**POWER LINE FROM THE
RHEBOKSFONTEIN WIND ENERGY
FACILITY TO THE AURORA SUBSTATION,
WESTERN CAPE PROVINCE
(DEA REF: 14/12/16/3/3/1/1533)**

**MOTIVATION FOR AMENDMENT OF
ENVIRONMENTAL AUTHORISATION**

DOCUMENT FOR PUBLIC REVIEW

NOVEMBER 2016

Figure 3: Alternative 1C

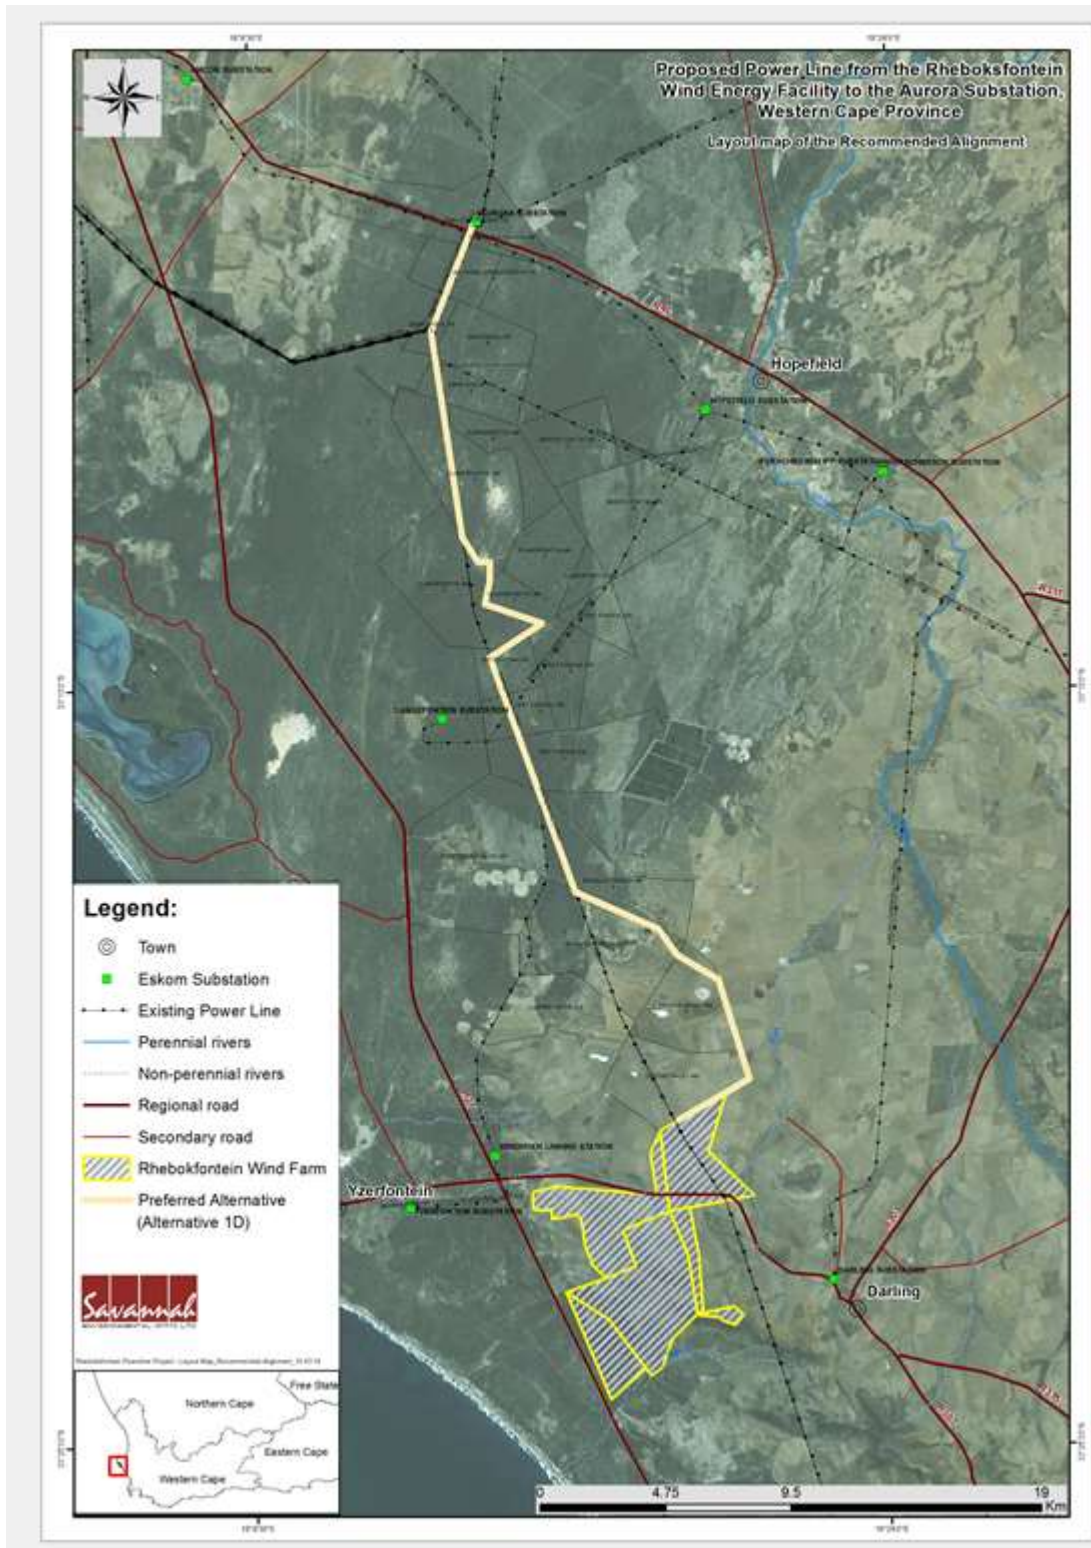
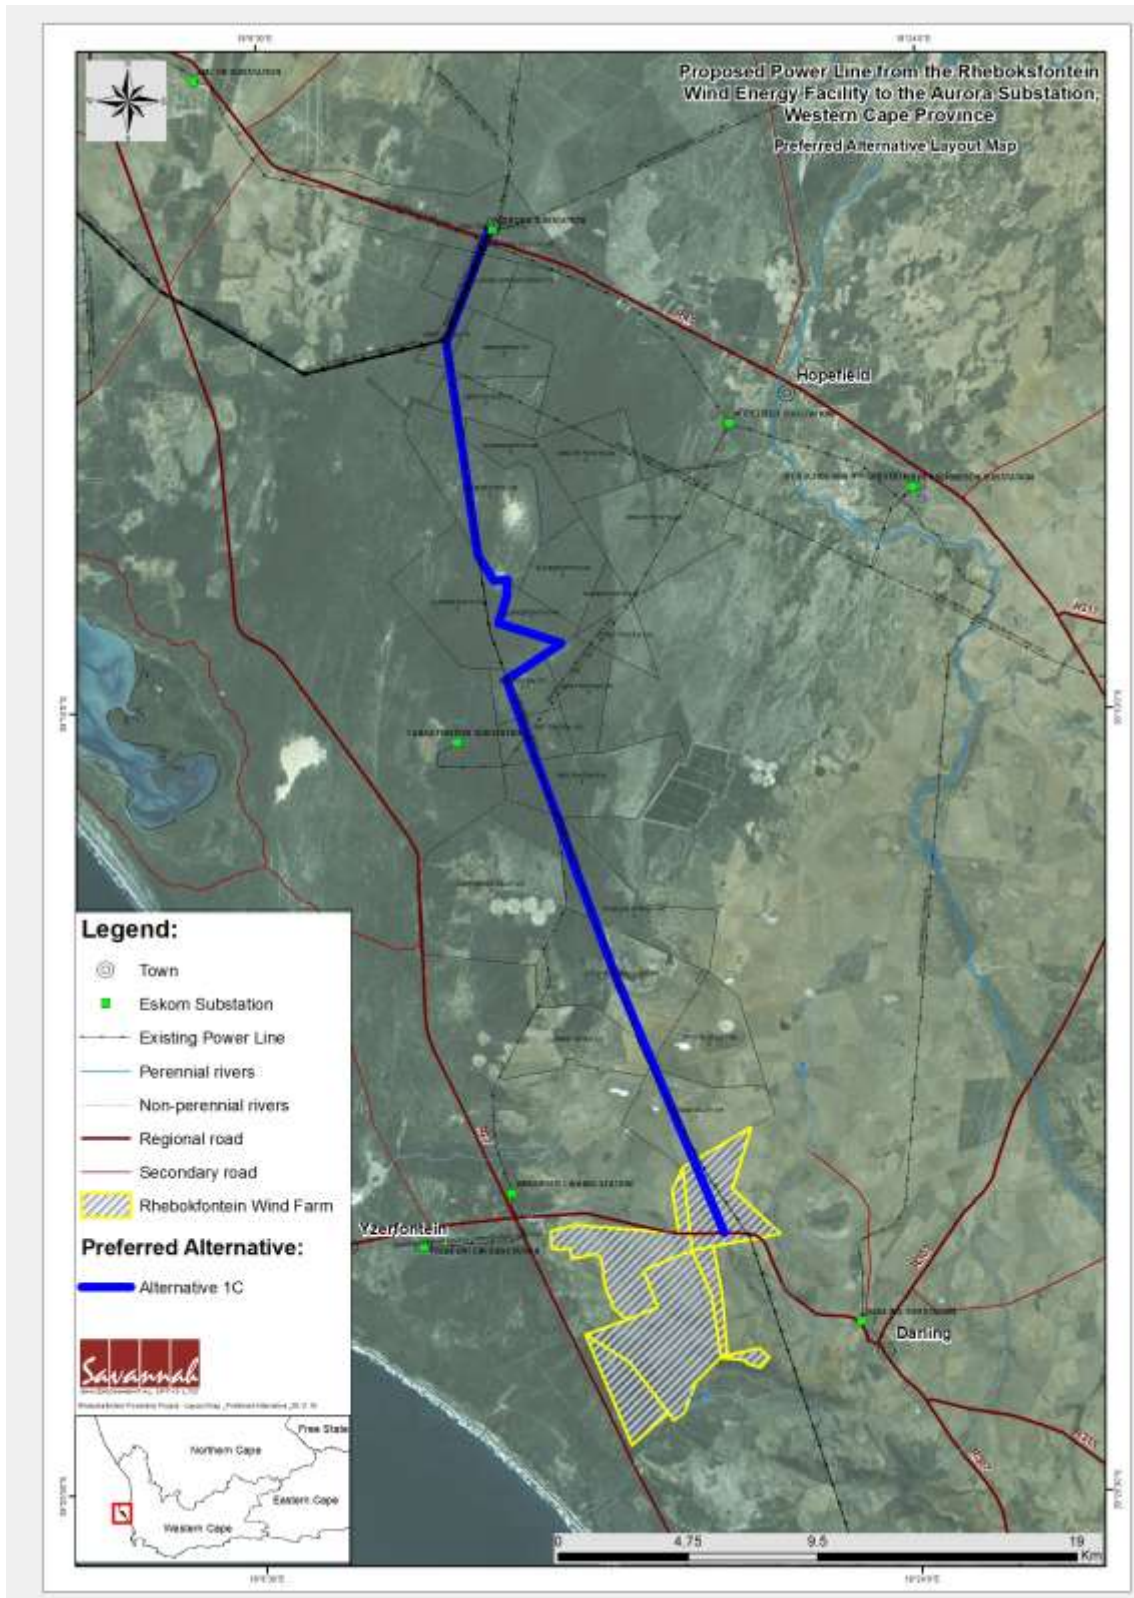
1. Amendment of approved route for the power line

It is requested that the preferred route be amended to Alternative 1C (as depicted in Figure 3), such that condition 1 states:

*"The preferred route Alternative **1C** for the construction of the 132kV power line from the Rheboksfontein Wind Energy Facility to the Aurora Substation, within the Swartland Local Municipality and Saldanha Local Municipality in the Western Cape Province, with the above-mentioned co-ordinates as indicated in the final BAR dated 15 April 2016 is hereby approved."*

Note: the start middle and end point co-ordinates of Alternative 1C are identical to Alternative 1D and therefore the co-ordinates on page 4 of the EA do not need to be amended.

Following objections raised by the affected landowners regarding the approval of Alternative 1D as the preferred alternative as a result of impacts on agricultural activities and land use, further discussions and recent on-site data collected by the bird specialist and Eskom, the findings of the impact assessment have been revisited and revised. Alternative 1C which runs parallel to the existing 400kV lines in the south is now regarded as the preferred option from an avifaunal perspective. This option would also reduce impacts on the land use for the affected landowners.

"The new 132 kV line must be routed on the west-side of the existing lines. Spiral bird diverters must be added to the earth wires of all new lines once the exact positions of the towers have been surveyed and pegged. An avifaunal specialist must be hired to assess the efficiency of the bird diverters every 6 months."
